**FINAL  
BASIN A NECK  
GROUNDWATER INTERCEPT AND  
TREATMENT SYSTEM  
INTERIM RESPONSE ACTION  
ALTERNATIVES ASSESSMENT  
VERSION 3.2**

**SEPTEMBER 1988**

Re: State Comments on Draft Final Basin A Neck Groundwater Intercept and  
Treatment System Interim Response Action Alternatives Assessment,  
June, 1988.

RESPONSES TO COMMENTS OF  
COLORADO DEPARTMENT OF HEALTH ON  
DRAFT FINAL BASIN A NECK GROUNDWATER INTERCEPT  
AND TREATMENT SYSTEM INTERIM RESPONSE ACTION  
ALTERNATIVES ASSESSMENT

Figure 4-1

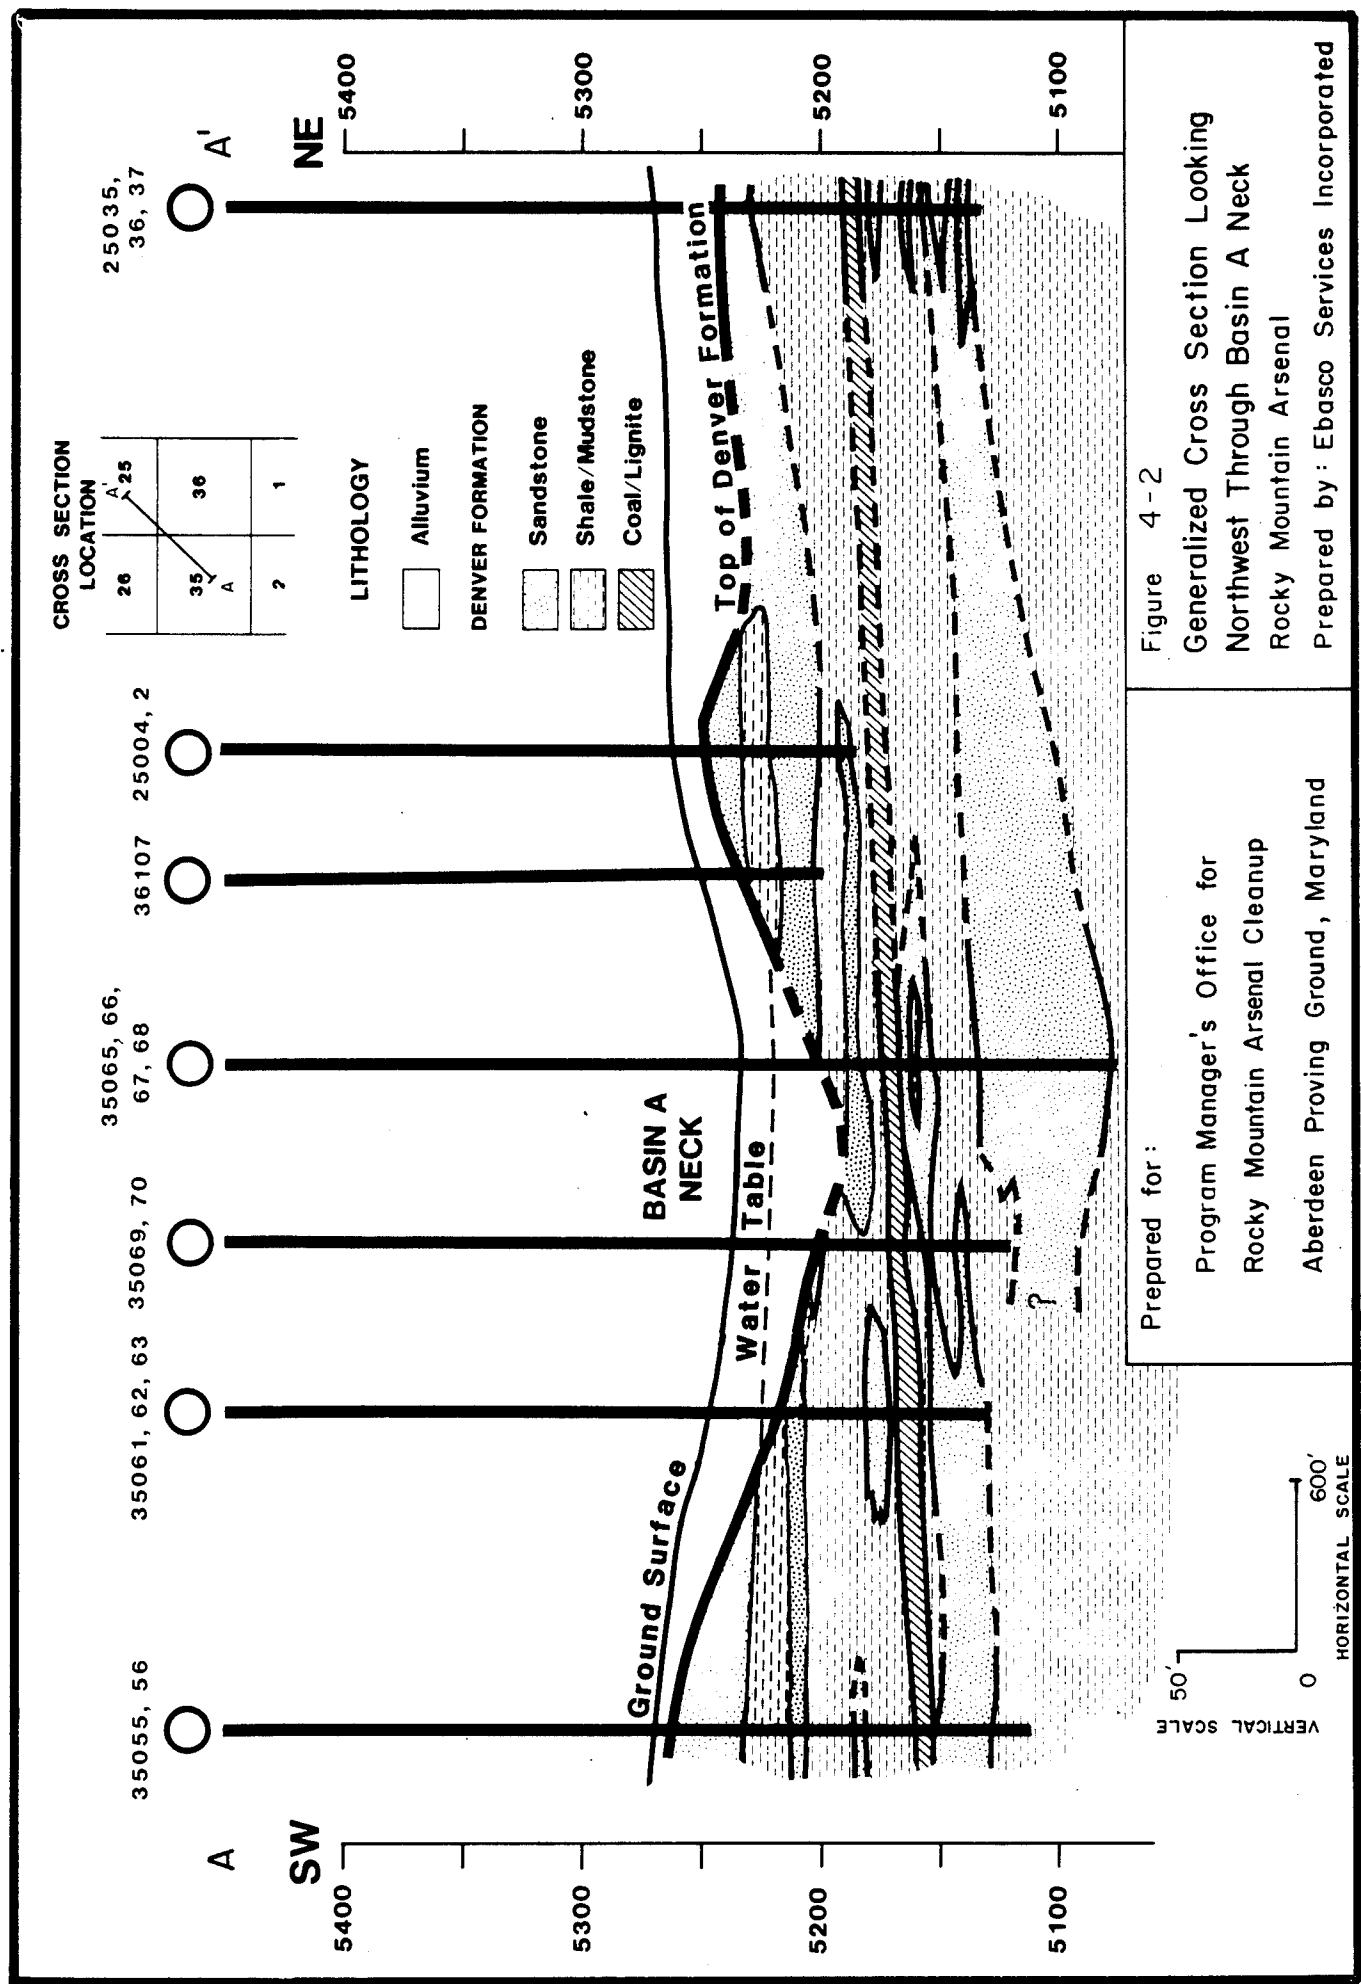
Comment 7: Pg. 42, Table 6.2-1 - Has the remote (Denver formation) component of the proposed narrow Basin A neck system been included in all cost estimates? This report should include separate cost estimates for the two components of the narrow Basin A neck system.

Construction in areas utilized by bald eagles has so far been restricted during the period November 1 to April 1. Bald eagles are known to use portions of the area mapped in Figure 4-1 of the Assessment document. Depending upon the final selection of the response alternative and the contaminated areas to be affected by construction, we recommend you contact either Mr. Pete Gober in Golden (236-2675) or Mr. Mike Lockhart of this office (303-243-2778) for specific guidance required to insure against unnecessary disturbance of wintering bald eagles.

Response: The extent of lateral Denver Formation sand units has not been established. The location shown in Figures 4-1 and 4-4 is conceptual and is not intended to delineate the size of the system, only its approximate location. There is insufficient data at this time to develop costs for the remote Denver Formation component of the intercept system. The costs presented in Table 6.2-1 do not reflect the costs associated with the remote system. The text has been modified to clarify this point.
